PRAIRIE ISLAND NUCLEAR GENERATING PLANT

License Amendment Request Dated May 6, 1980

PROPOSED CHANGES TO THE TECHNICAL SPECIFICATIONS
APPENDIX A OF OPERATING LICENSES
DPR-42 & DPR-60

FIGURE TS.3.10-7

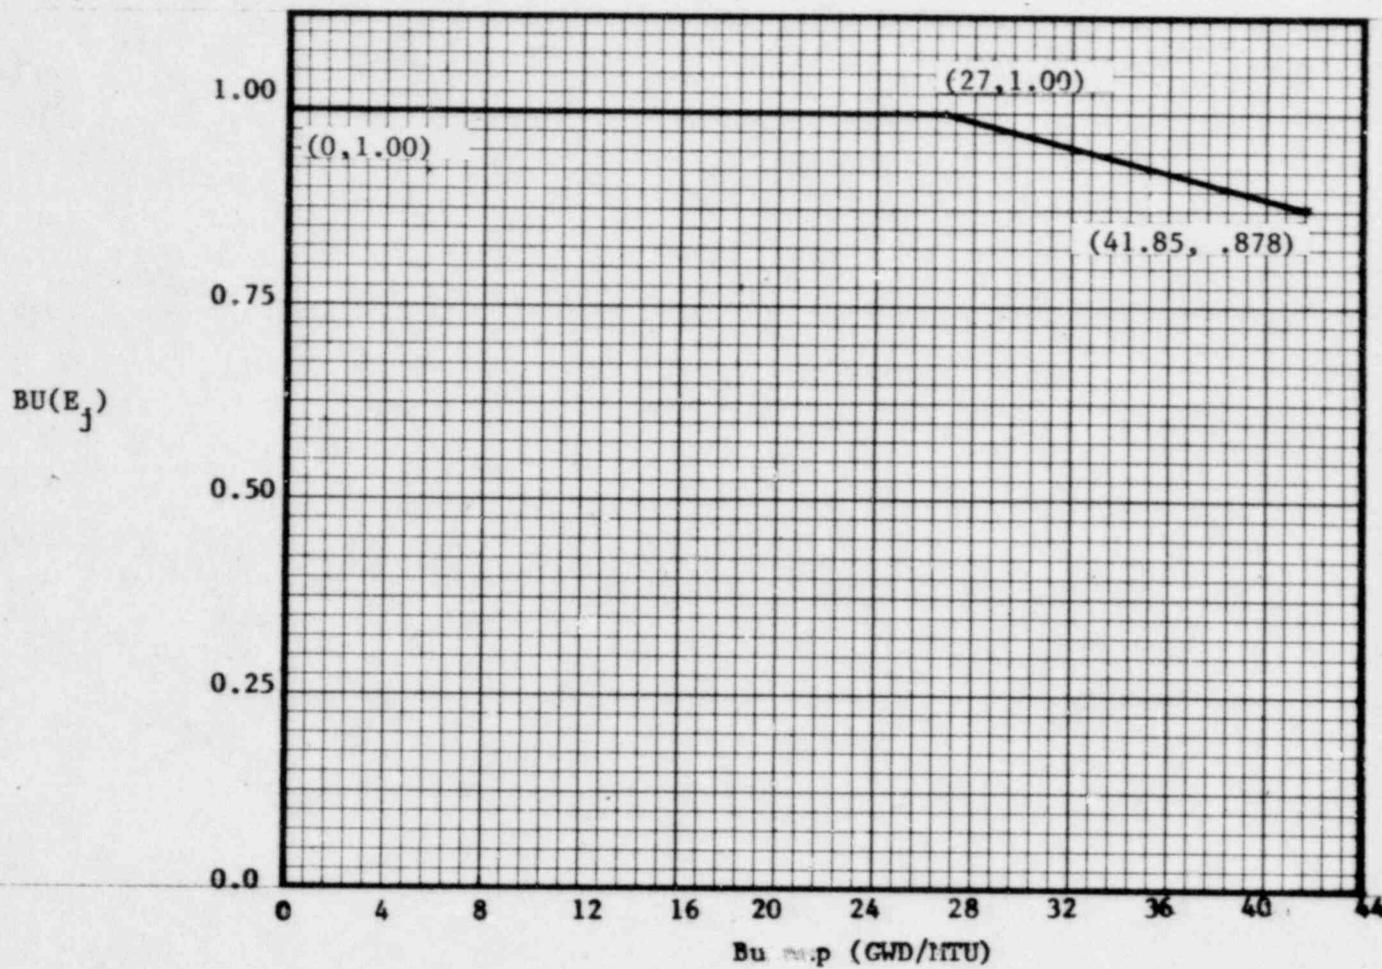
Changes attributable to exposure dependence of F_Q^N are included in specification 3.10.B.1. and Figure TS.3.10-7. Simply stated, these changes are -

- (1) redefining the limit in a form in which the measured F_Q^N is to be compared to the analytically determined F_Q^N .
- (2) Including a normalized exposure dependent function.

The $BU(E_j)$ function shown in Figure TS.3.10-7 is a normalized function that limits $F_Q(Z)$ based on exposure dependent analyses for the ENC fuel. These analyses consider pin internal pressure uncertainties, fuel swelling, rupture pressures, and flow blockage.

Reason for Change

10CFR 50.46 requires that selected acceptance criteria are met. This change is necessary to assure that those criteria are met.

Safety Evaluation

The data presented clearly shows that 10CFR 50.46 criteria are met over the span of expected peak pellet exposures. Variation of the F_Q^N limit with burnup assures that the 50.46 criteria are met. This variation should not affect power operation of the Prairie Island units since F_Q^N limit decrease is not expected until late in the second cycle or early in the third cycle when F_Q^N values would be lower. The data is conservative relative to the higher burnup fuel (References 6, 11).
